ADDENDUM

Project Name: Restroom Renovation at Central Fire Station

Project Number: 6027

Addendum Number: 1

A1.0

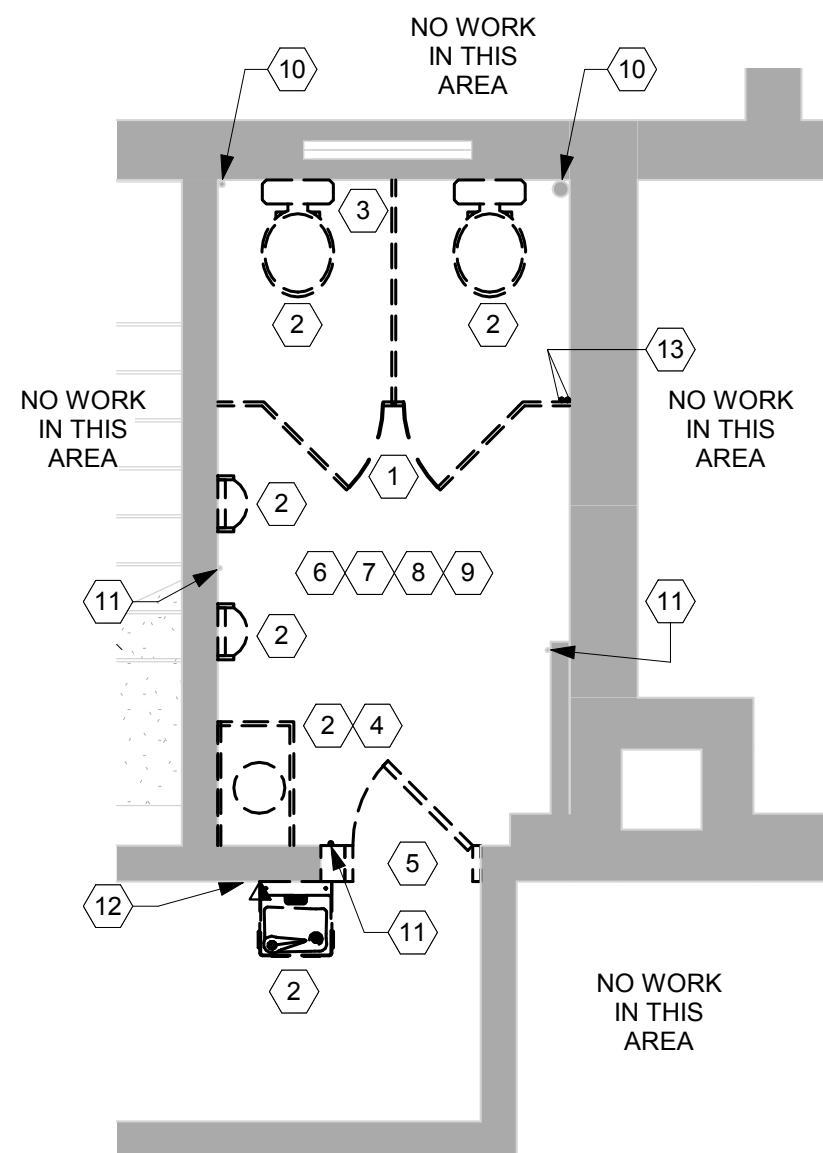
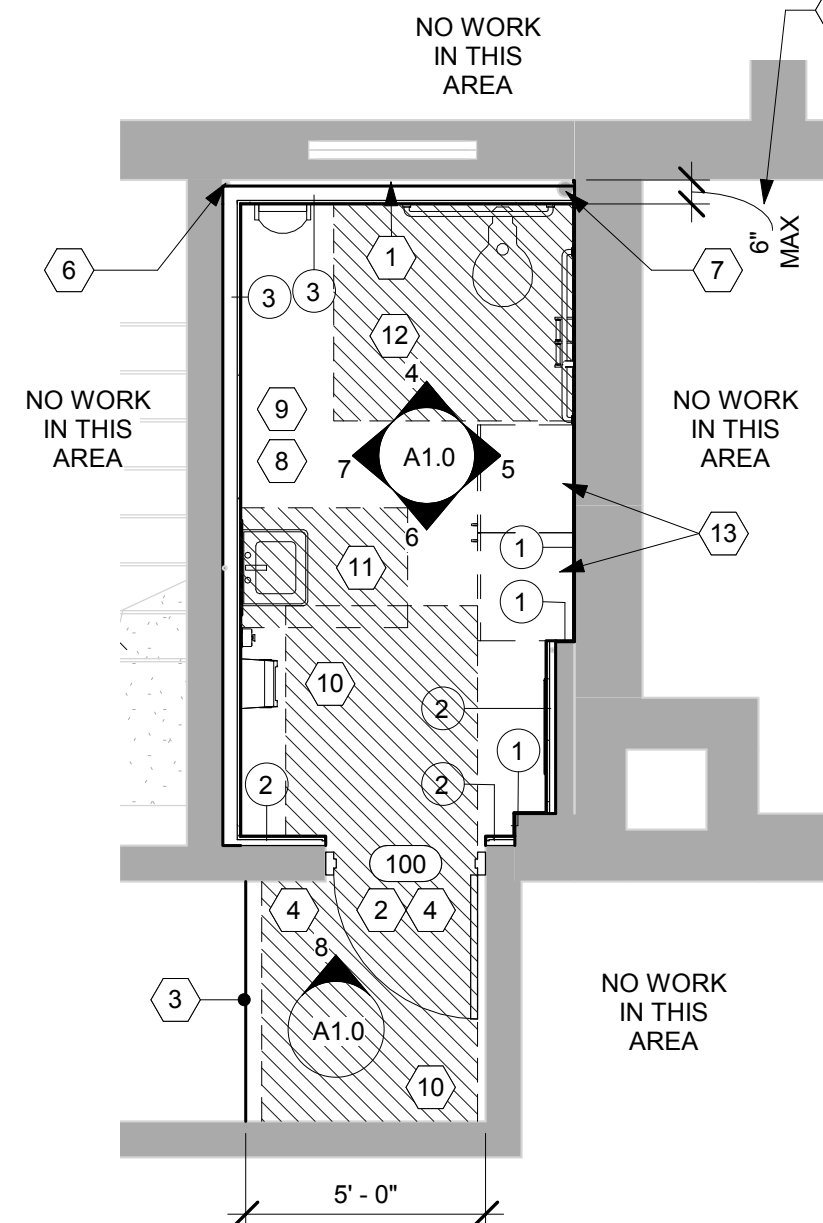
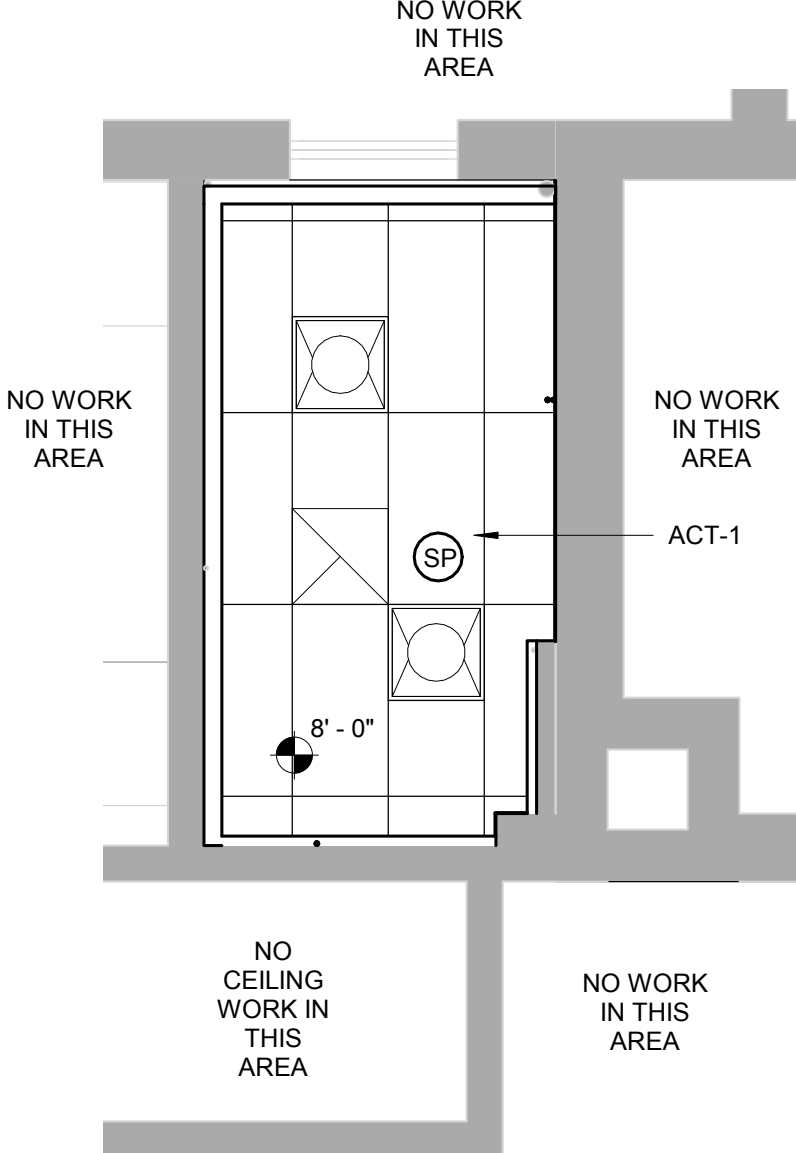
ITEM	DESCRIPTION	NOTES
SPECIFICATIONS:		
Section 00 4113	Replace	Replace with attached section.
DRAWINGS:		
Sheet A1.0	Replace	Replace with attached sheet - demo scope revised, wall construction revised, floor finish and wall finish revised.
Sheet A2.0	Replace	Replace with attached sheet - demo scope revised, wall construction revised, floor finish and wall finish revised.
Sheet MEP2.0	Add	Remove existing wall occupancy sensor/switch. Modify circuit as required and install new occupancy sensor/switch in new wall to control light fixture.
Sheet MEP2.0	Add	Modify existing plumbing piping as required and connect ice maker drain in adjacent stairwell into new plumbing.
